Paper for Consideration by the ENCWG

Issues on S-64 Ed 3.0.2

Submitted by:	Hannu Peiponen / Furuno Finland
Executive Summary:	This paper is about issues found in the latest edition 3.0.2 of S-64.
Related Documents:	S-64 Ed 3.0.2, Jul 2017
Related Projects:	N/A

GB4X0000, S-64 Ed 3.0.1 – M_QUAL/CATZOC available both over water and land

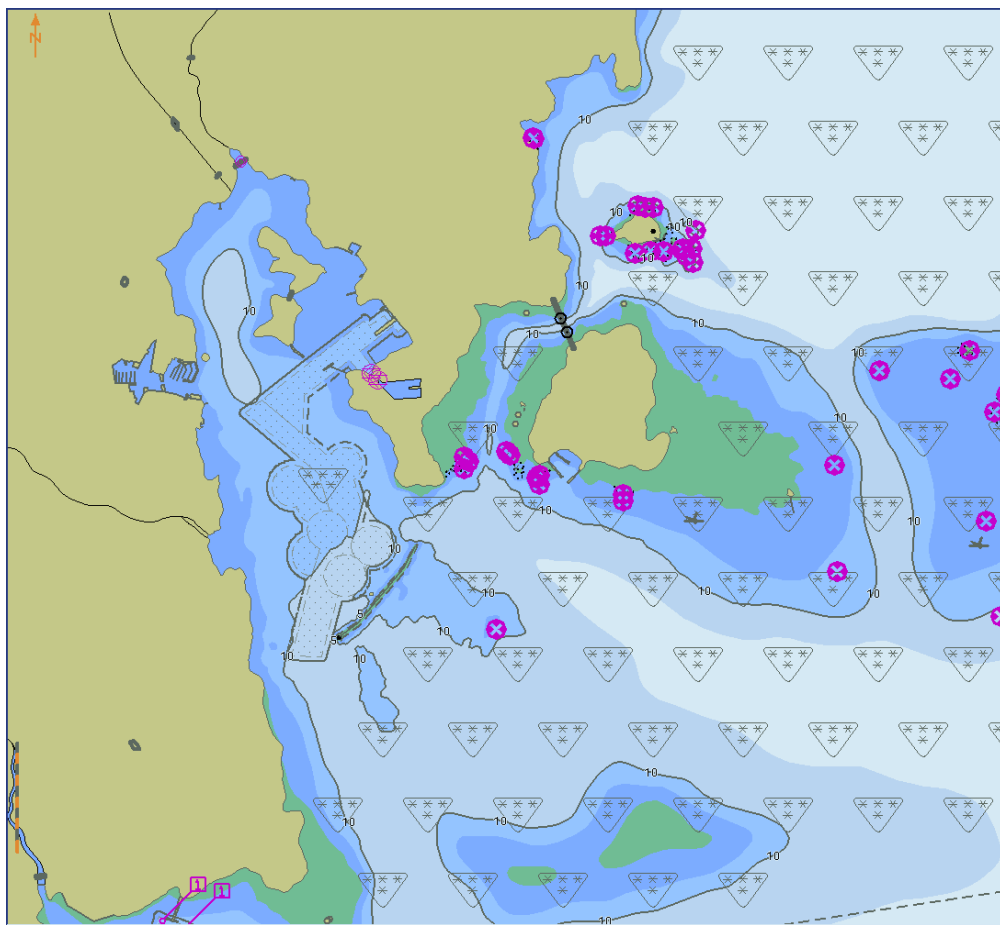
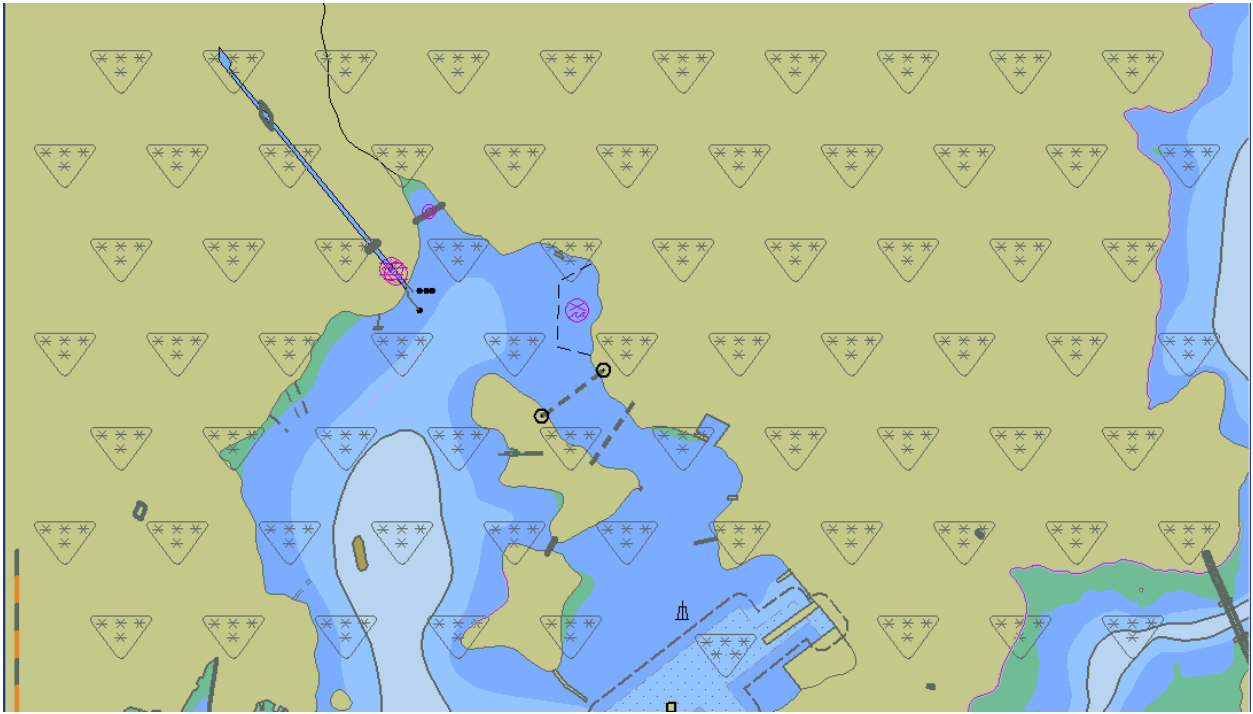
4. M_QUAL/CATZOC areas of charts GB4X0000, GB5X01NW and GB5X01NE has been amended.

- One change has been removal of overlapping M_QUAL/CATZOC areas. This change itself is obviously welcomed as overlapping M_QUAL are not allowed (See S-58), but the screen samples in **tests 2.1.1, 2.2.2, 2.2.4, 2.2.6, 2.2.8 and 3.7.1b** have not been updated.
- Another change has been that there is no M_QUAL/CATZOC available for land areas. It should be noted that according S-57 UOC the M_QUAL is mandatory to cover areas containing depth data or bathymetry and that S-58 has extensive test for this mandatory use. However, there is no limitation in S-57 UOC nor in S-58 to use M_QUAL over land areas. This change of removal of M_QUAL from land areas might not be what is wanted. At least it has significant impact as there are 21 pieces of screen samples to be revised to fix this change in tests 2.1.1, 2.2.2, 2.2.4, 2.2.6, 2.2.8 and 3.7.1b.

13. Biggest issue is what to do with changed CATZOC areas in charts GB4X0000m GB4X01NW and GB5X01NE. There are two alternatives. Either expand CATZOC to cover all land area as in previous editions of S-64 or create 21 new screen samples. => obviously this should be fixed. Remaining is to decide which method to fix.

2J5X0001, S-64 Ed 3.0.1

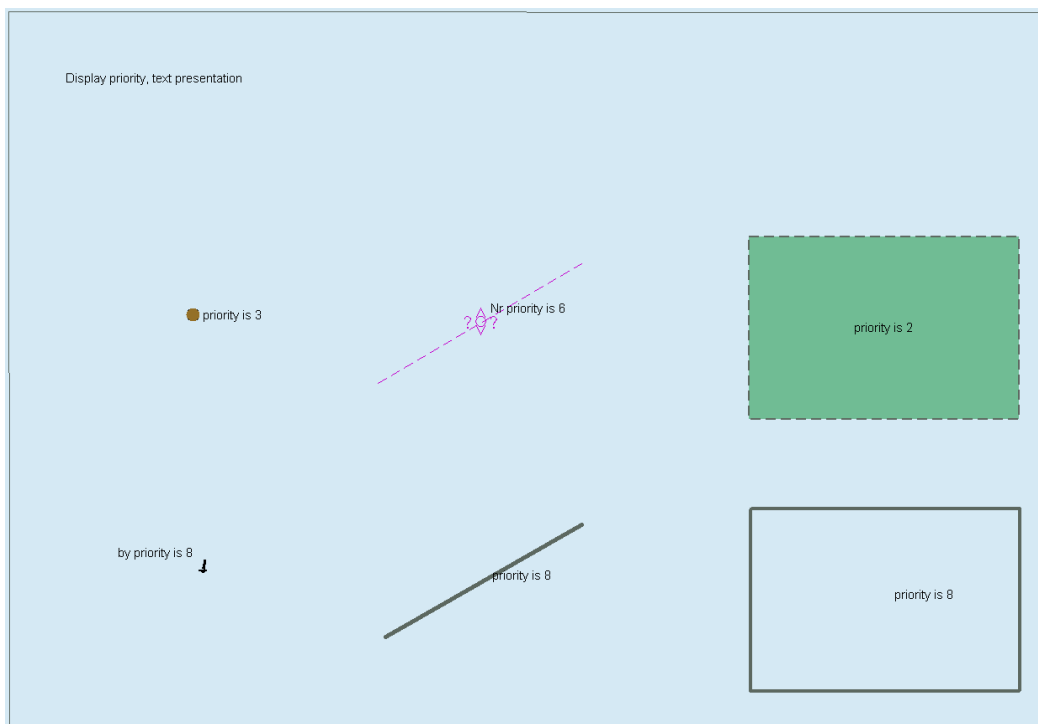
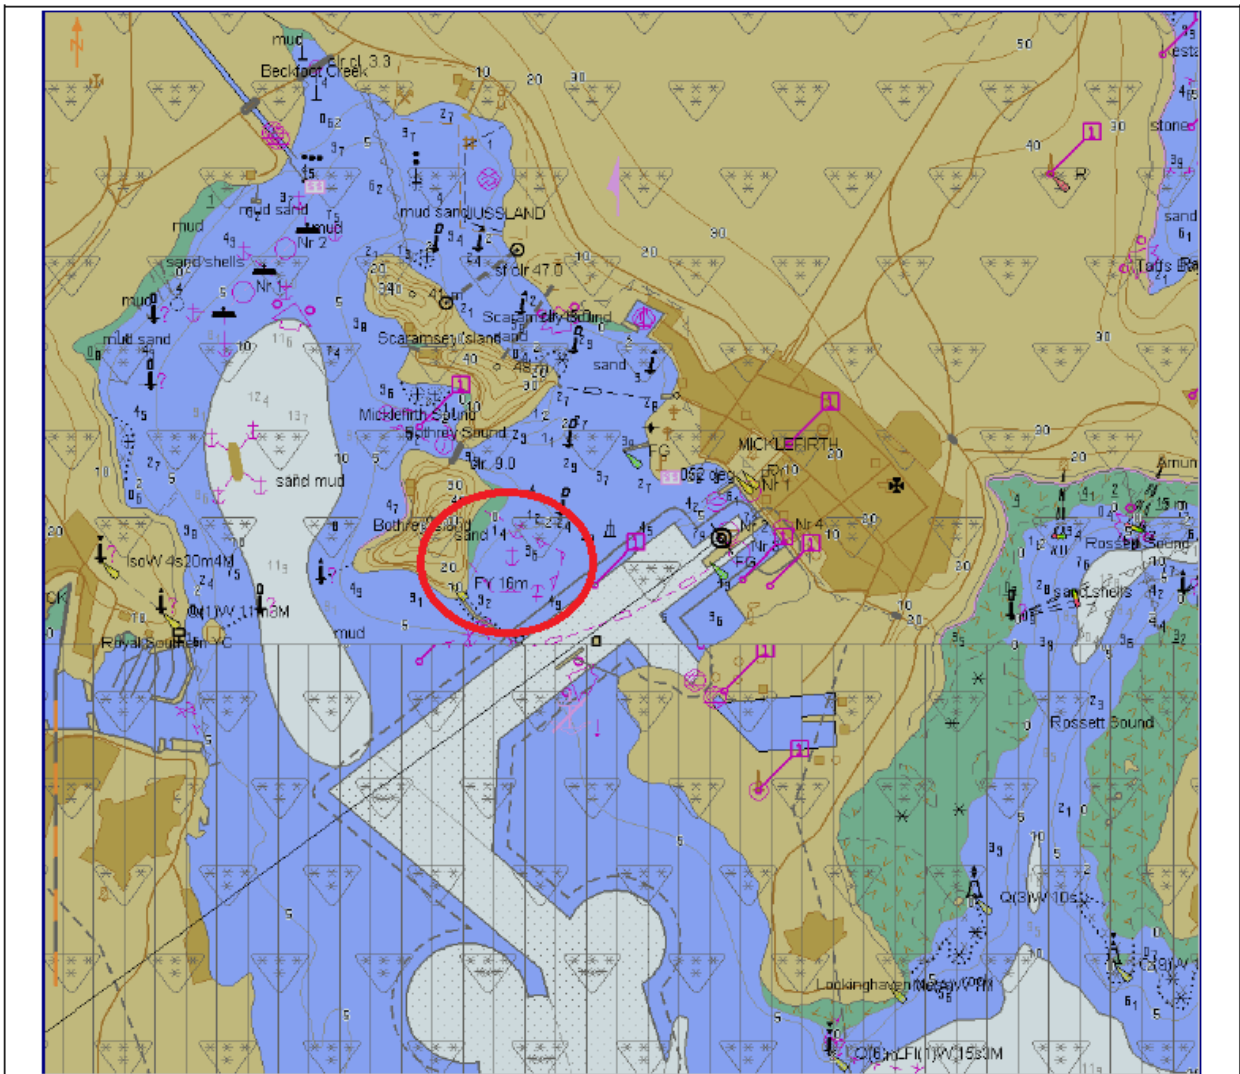
6. Content of the chart 2J5X0001 has been changed so that the **test 3.6.5** cannot be passed

3rd screen sample for test 2.1.1, area of drawing error inside the red circle

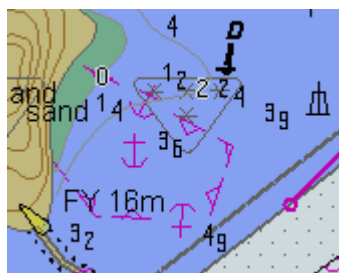
7. 3rd screen sample for test 2.1.1 has an **error for drawing of anchorage area**. This error has nothing to do with changes of chart content between ed 3.0.1 and 3.0.2.

Error in presentation of anchorage area

11. Drawing error in 3rd screen sample for test 2.1.1 => clear mistake to be fixed by new screen sample

3.6.7 Display of unknown symbols

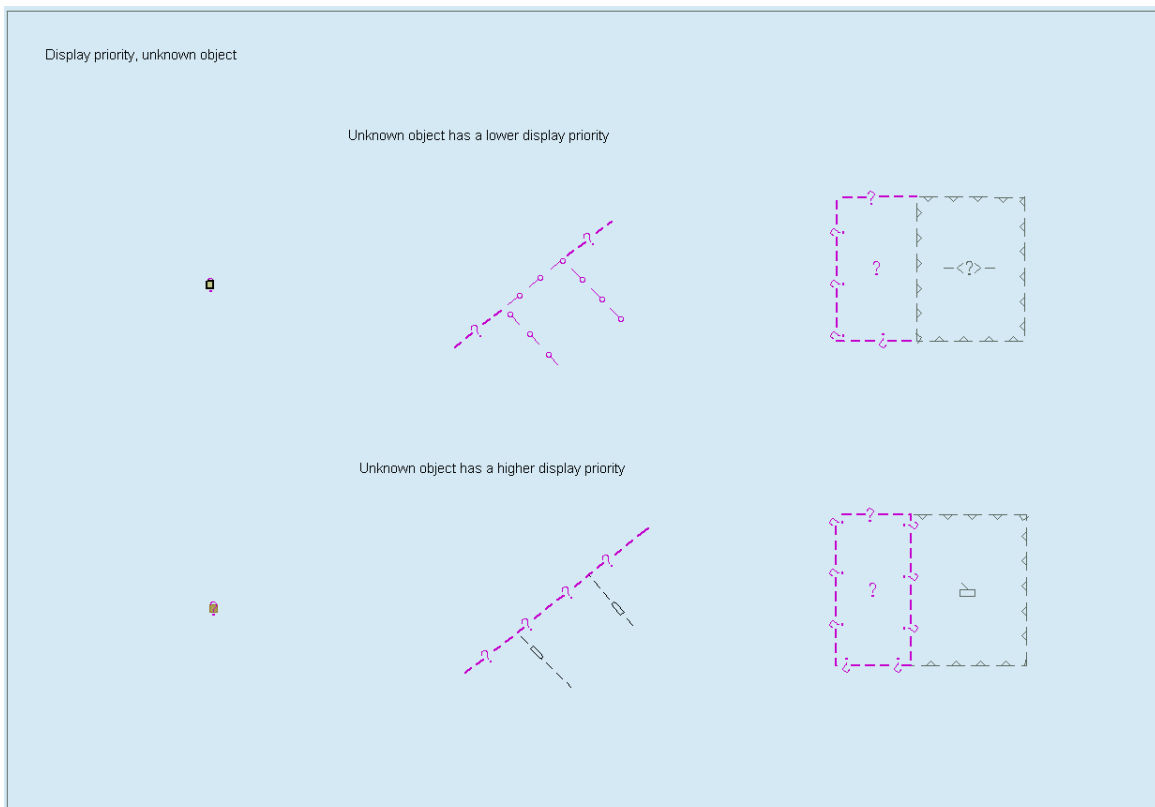
8. **Picture quality** of screen sample for **test 3.6.7** is **poor**. It is difficult to see what is correct line width for each feature in the test.

Proposal for better picture quality – possible to see difference between 1 and 2 pixel wide lines

12. Picture quality in test 3.6.7. This has no clear mistake, but users of the S-64 would benefit from better picture quality => consider to use a new screen sample
